McKinley High School – Construction Documents
800 E McKinley St, Baton Rouge, LA 70802
Domain Chasm Project No. C24-0038/24009

ADDENDUM NO. 2

2 SECTION DETAIL
1 1/2" = 1'-0" DRAWN BY:

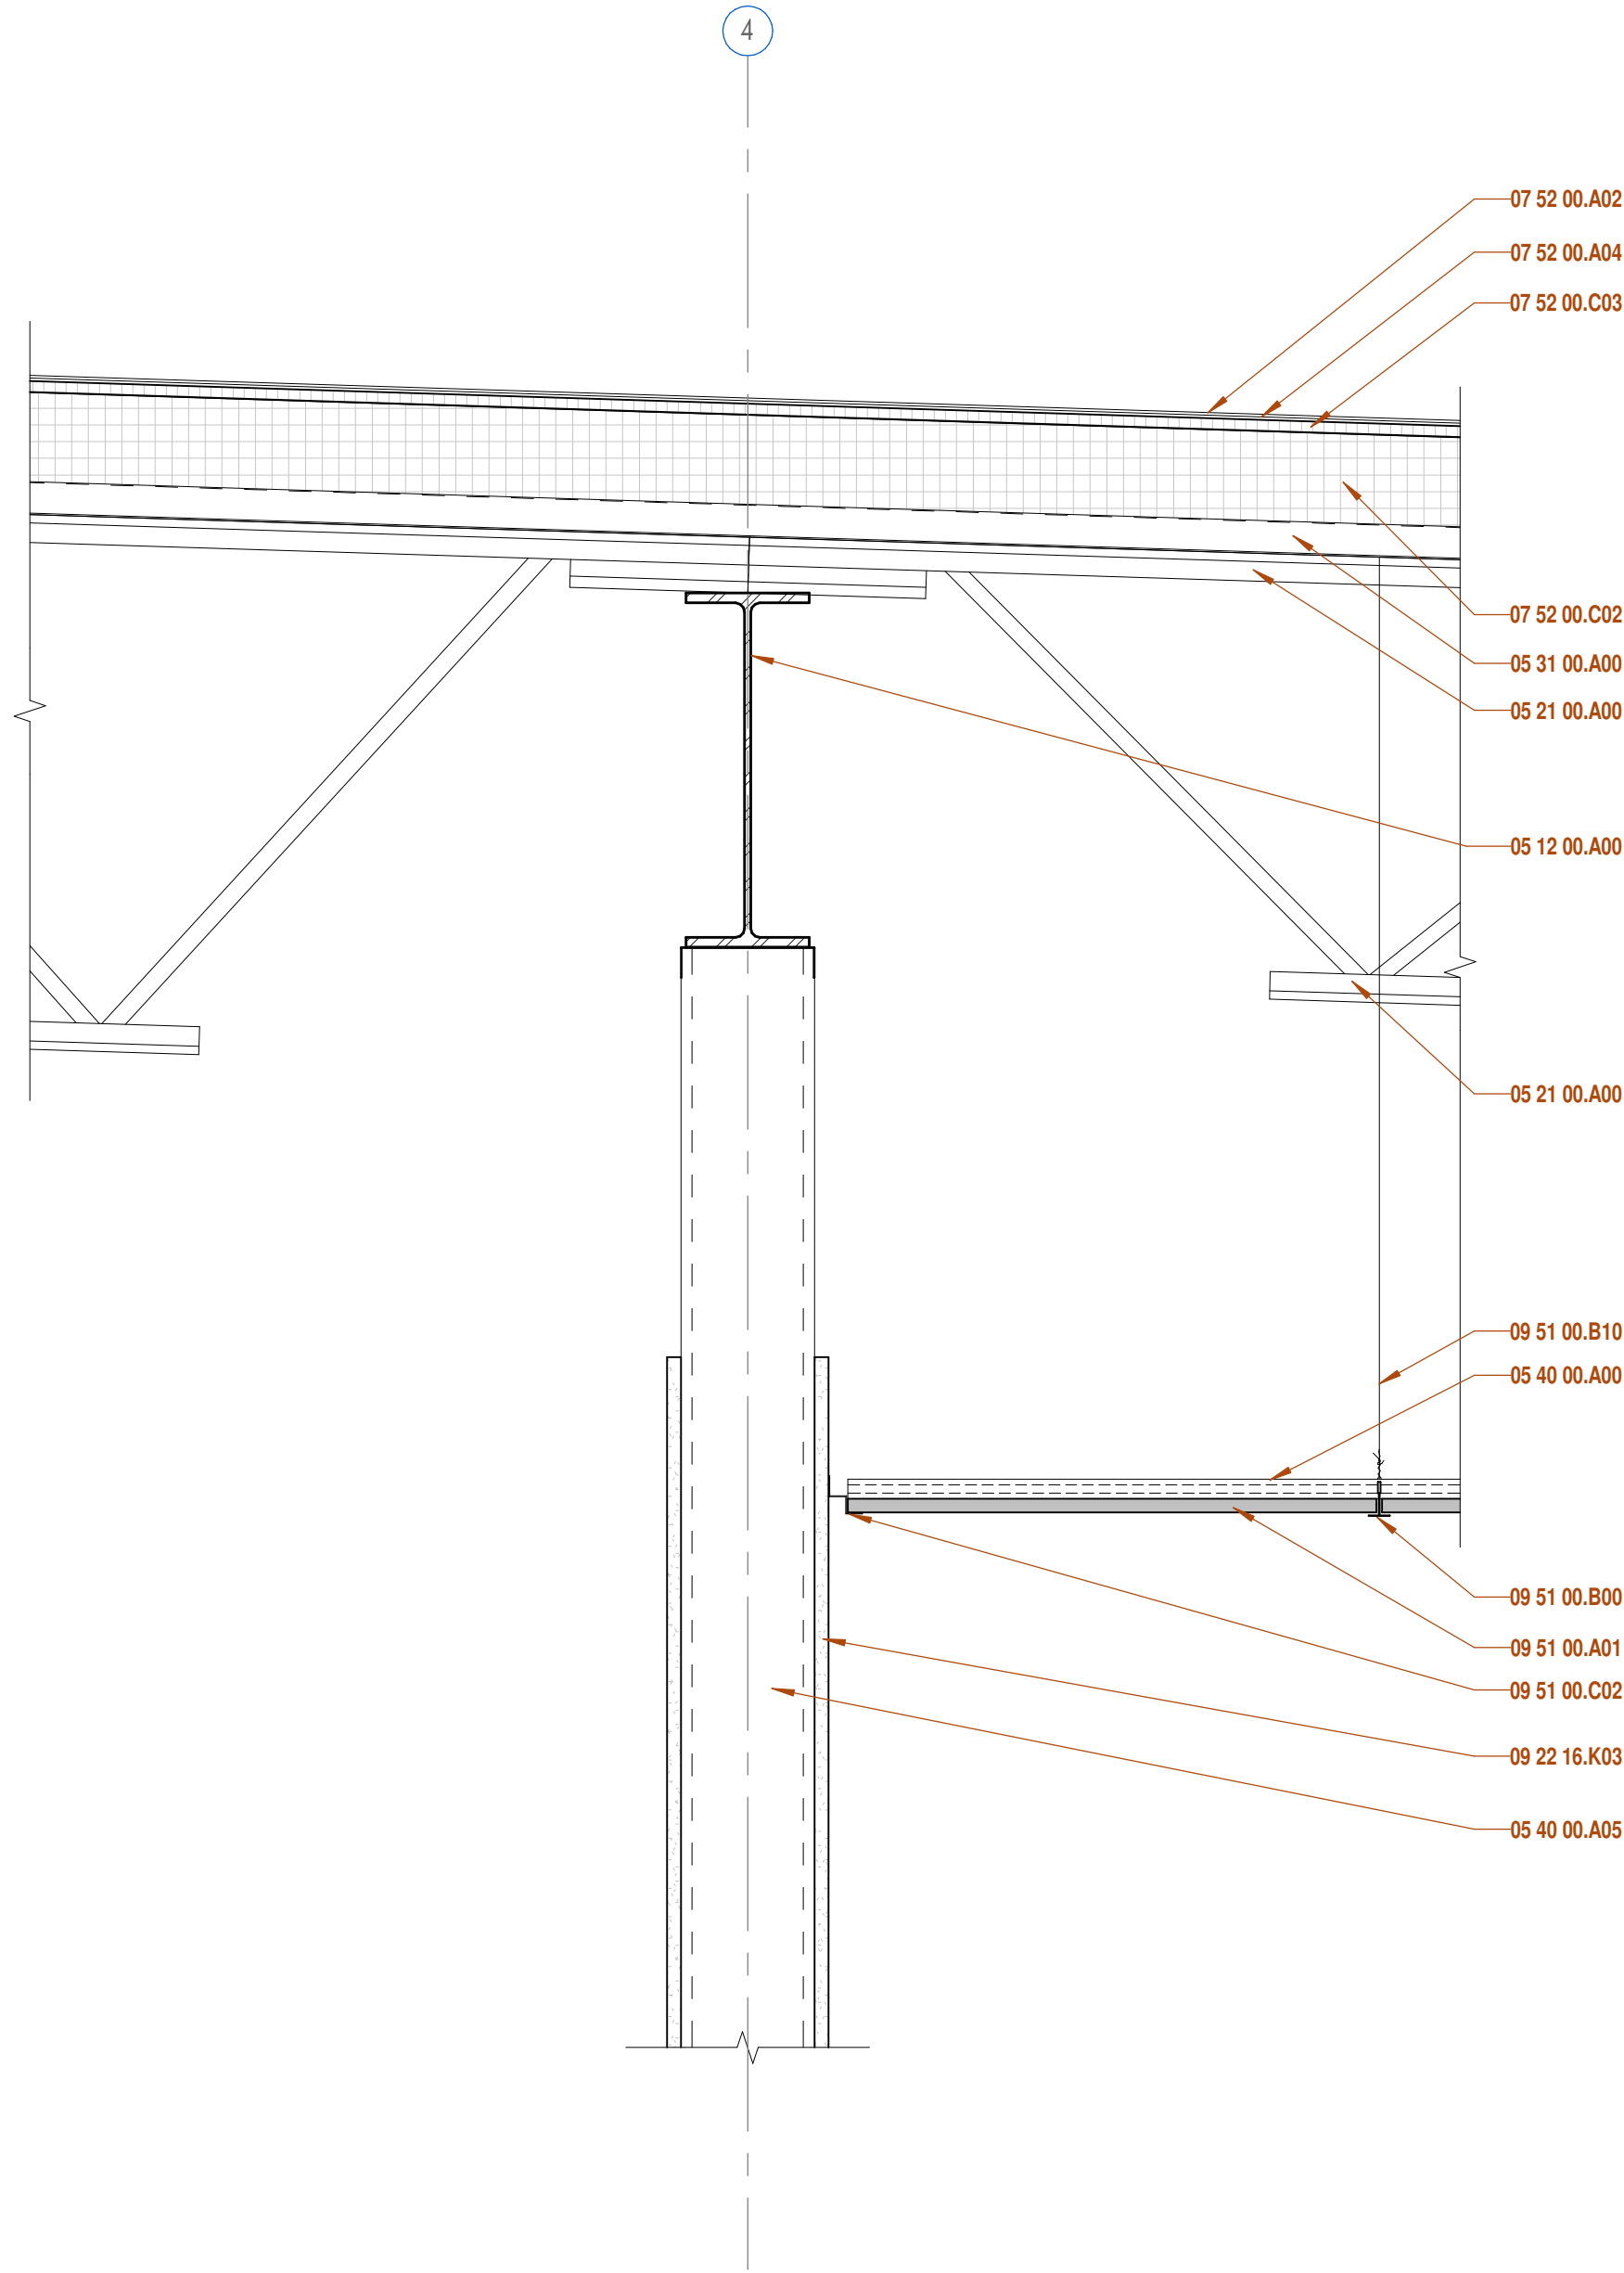
15. Sheet A8.712 - Section Details – New Arts Bldg. - Remove previously issued sheet and replace sheet with revised attached sheet.
 - a. Detail 3/A8.712 Section Detail – Added keynotes to detail.
